ARCHITECT'S SUPPLEMENTAL INSTRUCTIONS

Initiated By		Distributed To
Project:	Lumberyard District – Buildings 2, 6, 8 & 9 Omaha, NE	<input type="checkbox"/>	Owner	<input checked="" type="checkbox"/>
Project Number:	15927	<input type="checkbox"/>	Architect	<input checked="" type="checkbox"/>
Owner:	Lanoha Development	<input type="checkbox"/>	Contractor	<input checked="" type="checkbox"/>
To Contractor:	Overland Constructors 5036 South 135 th Street Omaha, NE 68145	<input checked="" type="checkbox"/>	Consultant	<input checked="" type="checkbox"/>
		<input type="checkbox"/>	Field	<input type="checkbox"/>
		<input type="checkbox"/>	Other	<input type="checkbox"/>
Supplemental Instruction No.:	004			
Date:	March 4, 2016			
Contract Date:	February 15, 2016			
Contract For:	New Construction			
By:	Holland Basham Architects

Description: Revised Fire department connection.

BUILDING 2 - FIRST FLOOR PLAN - AREA "A" - ABOVE GRADE PLUMBING

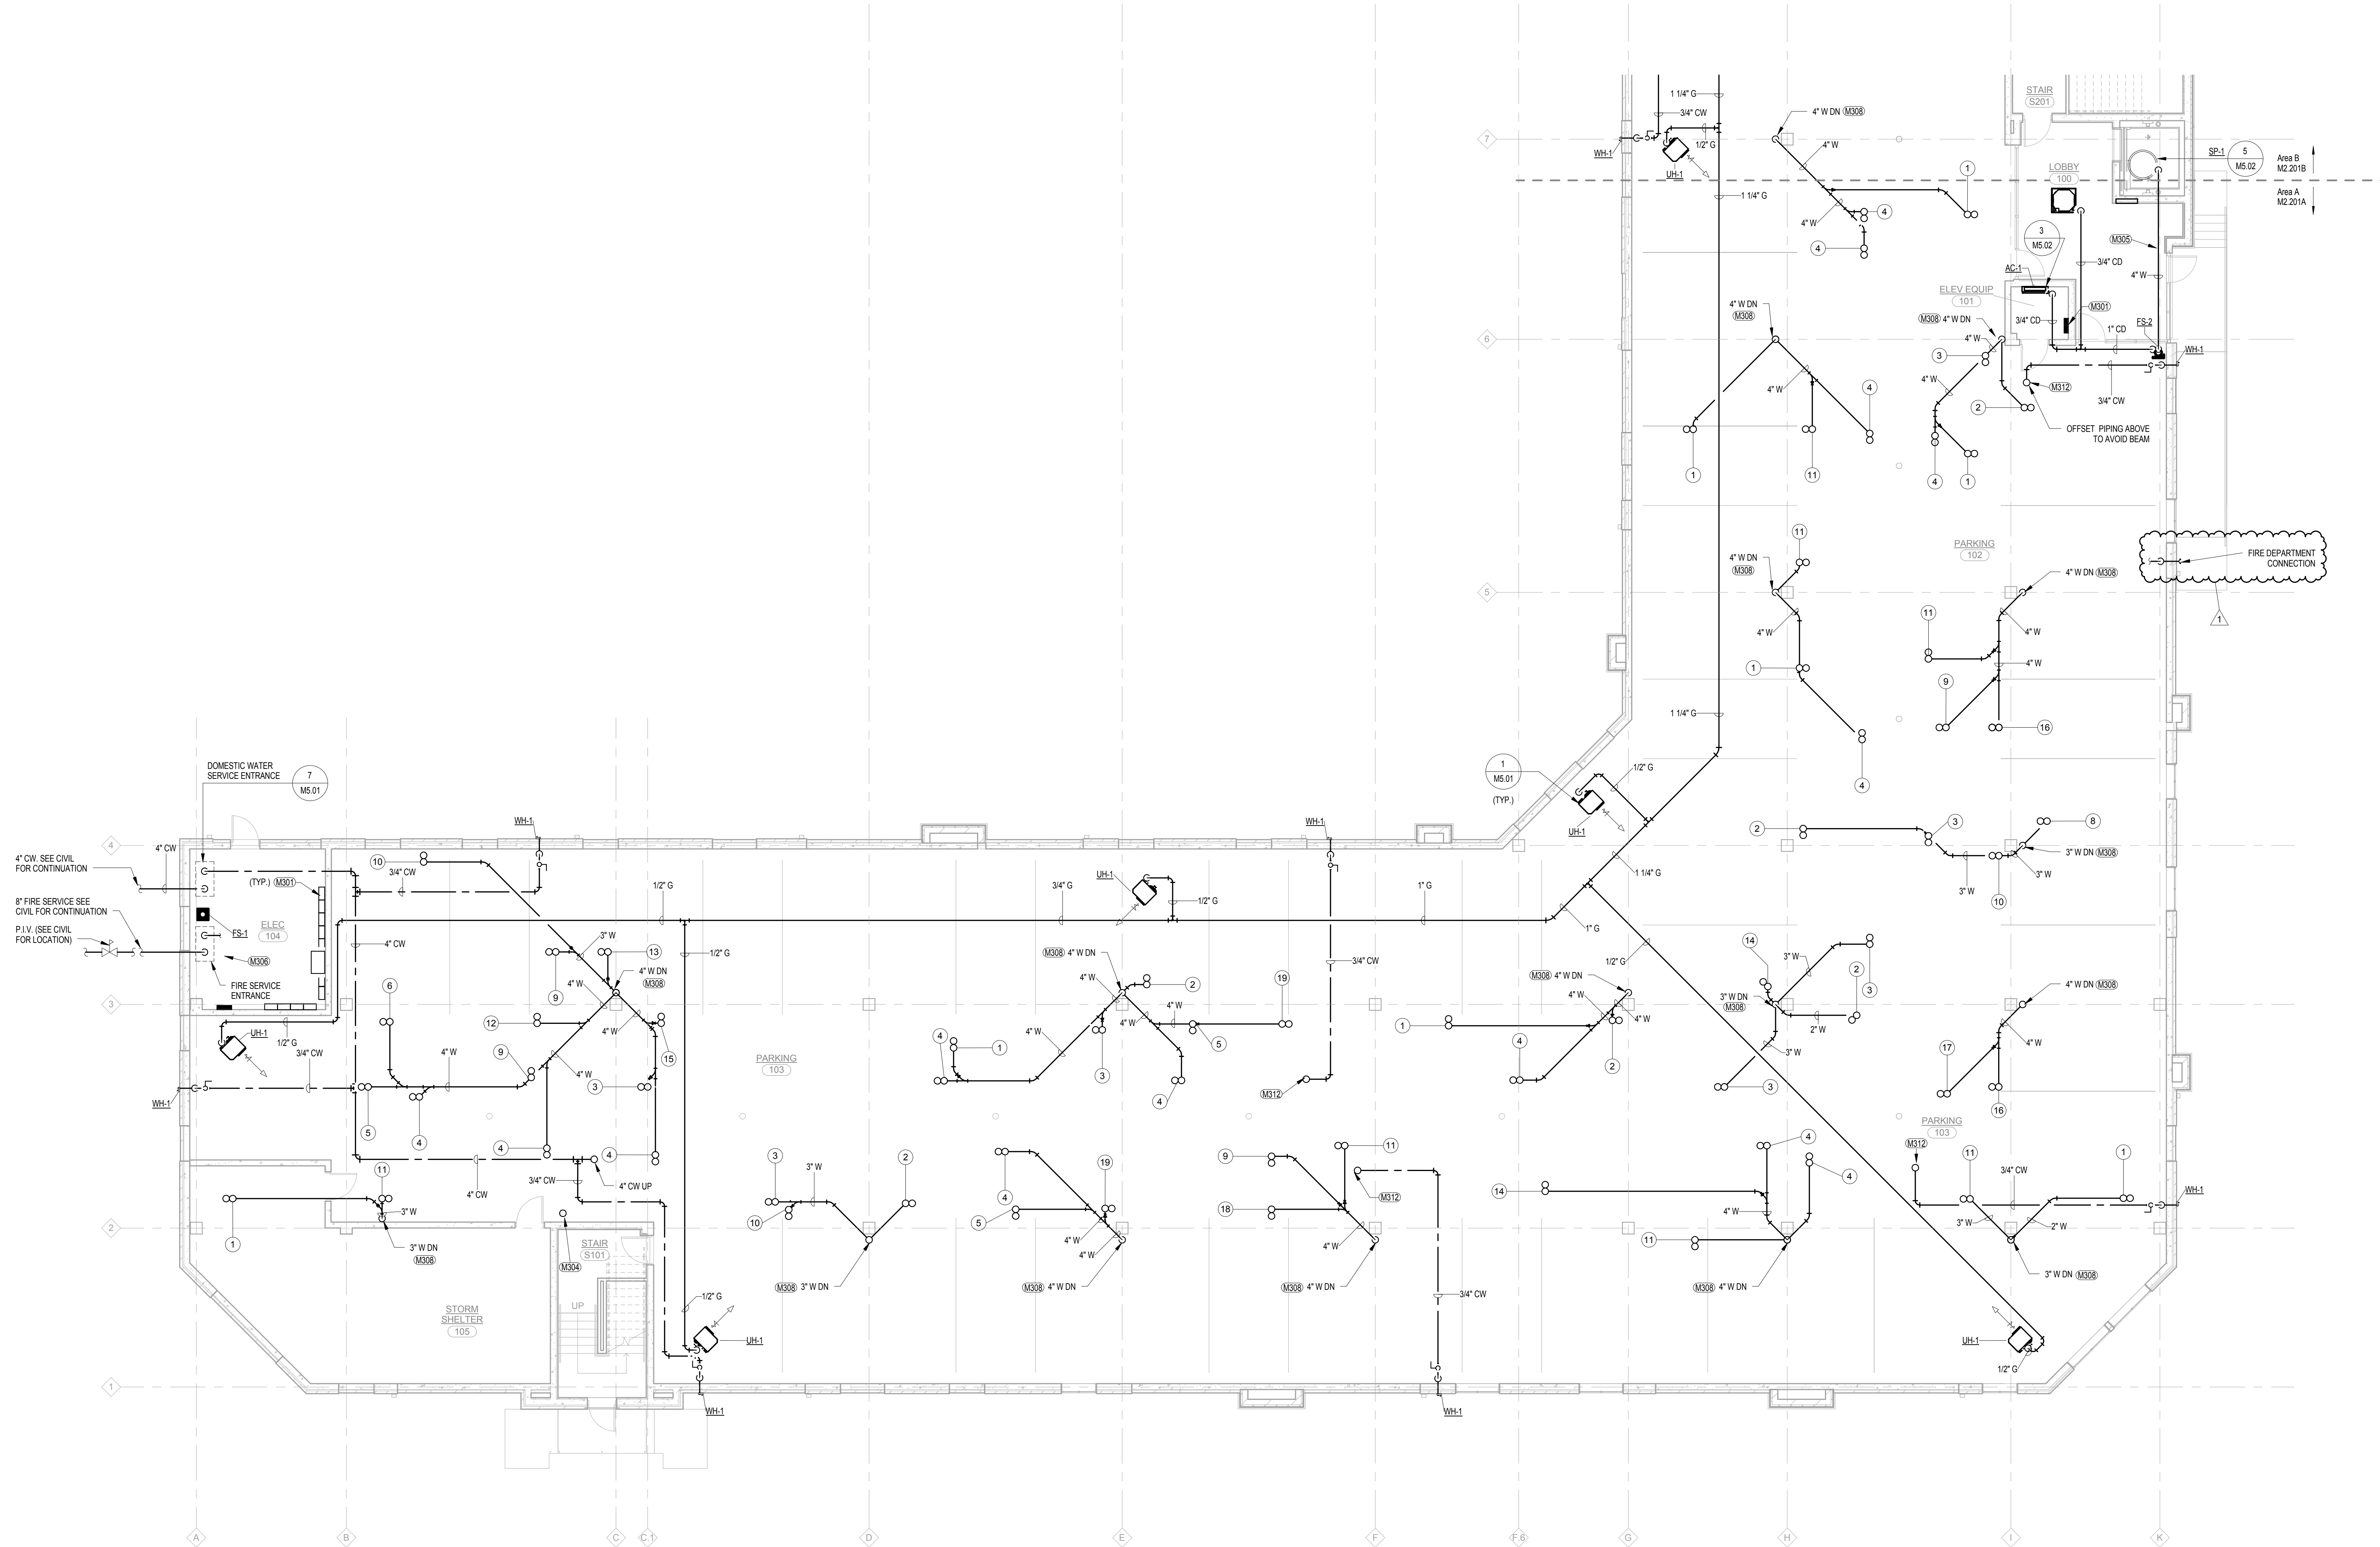
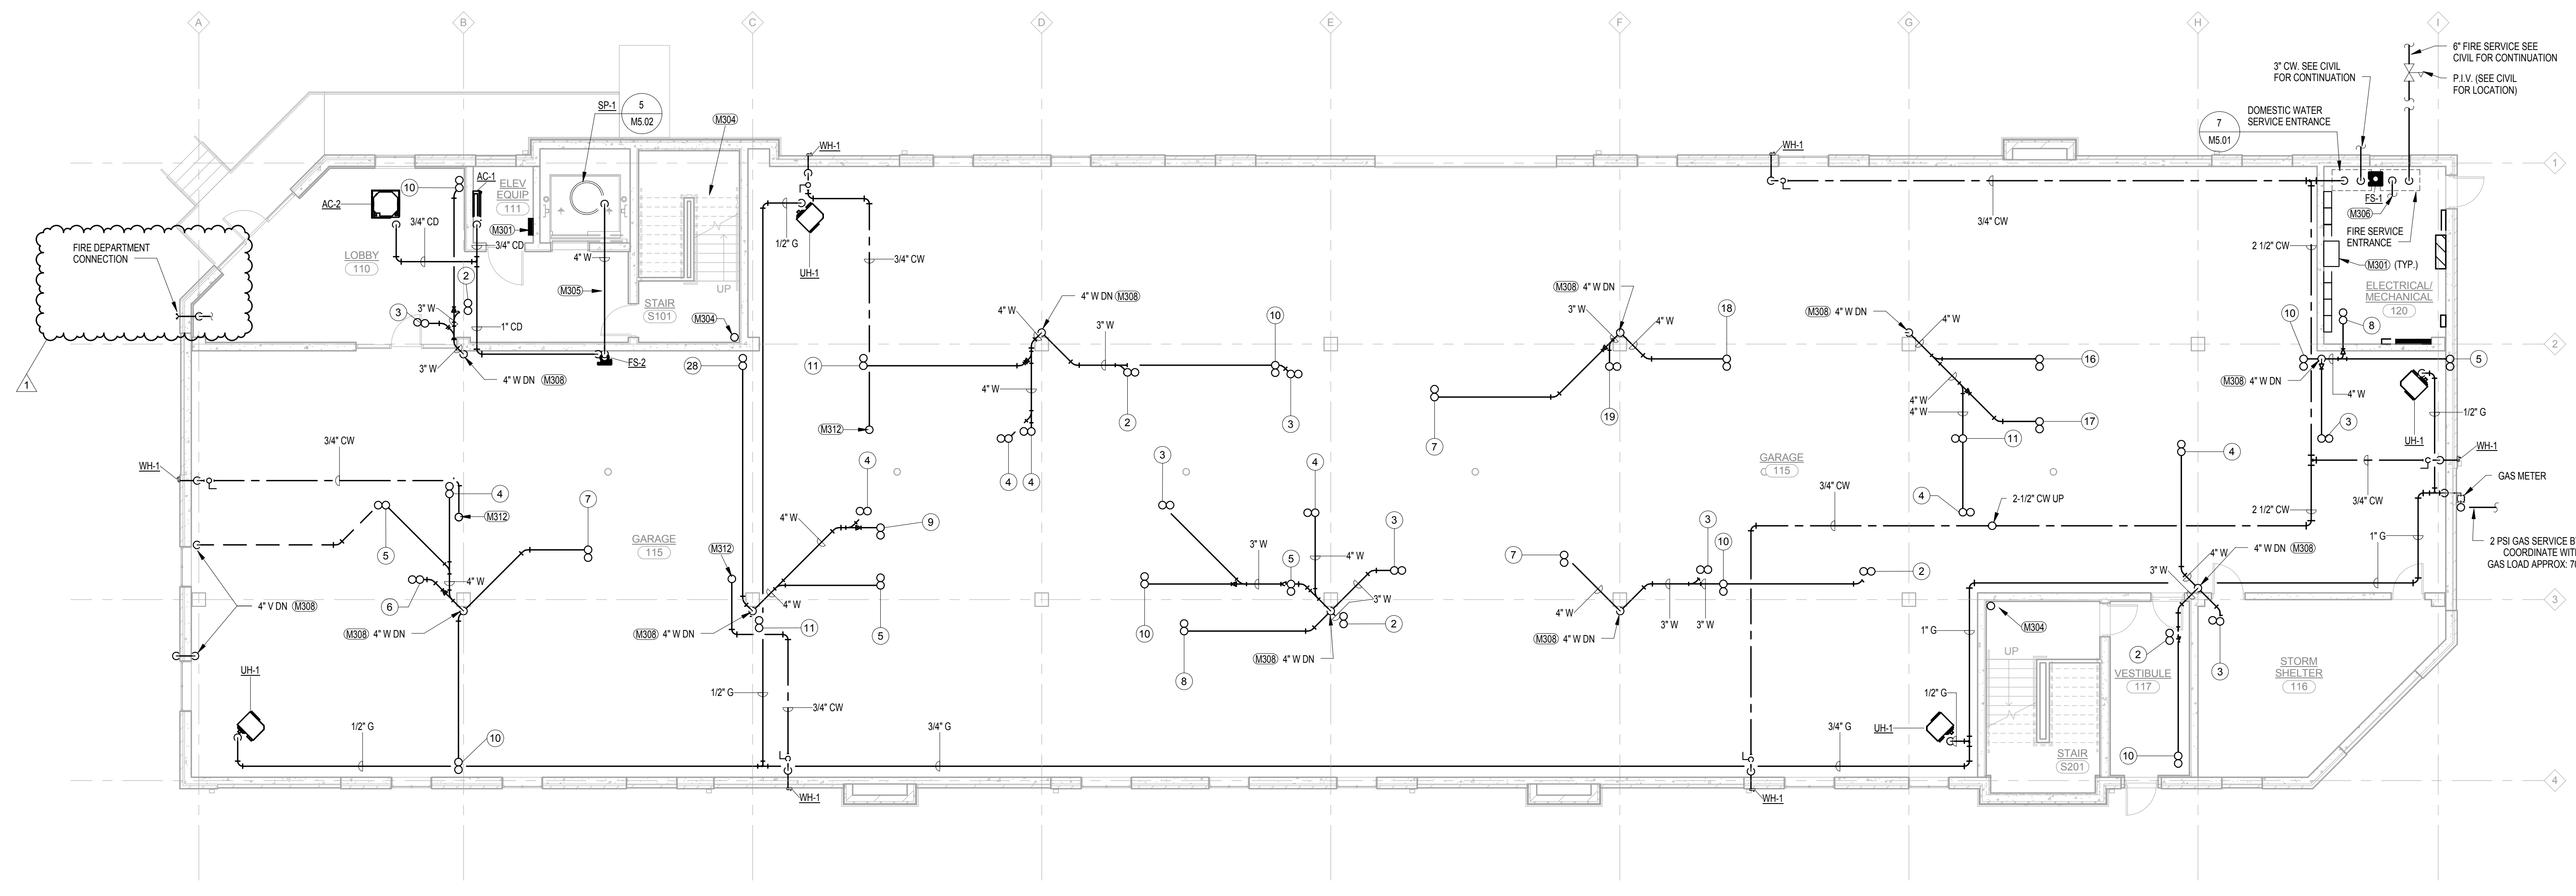
1. Sheet M2.201A – Building 2 – First Floor Plan – Area A – Above Grade Plumbing
 - a. Add Fire department connection as shown in attached Sheet M2.201A.
2. Sheet M2.601 – Building 6 – First Floor Plan – Above Grade Plumbing
 - a. Add Fire department connection as shown in attached Sheet M2.601.
3. Sheet M2.801B – Building 8 – First Floor Plan – Area B – Above Grade Plumbing
 - a. Add Fire department connection as shown in attached Sheet M2.801B.
4. Sheet M2.901 – Building 9 – First Floor Plan – Above Grade Plumbing
 - a. Add Fire department connection as shown in attached Sheet M2.901.
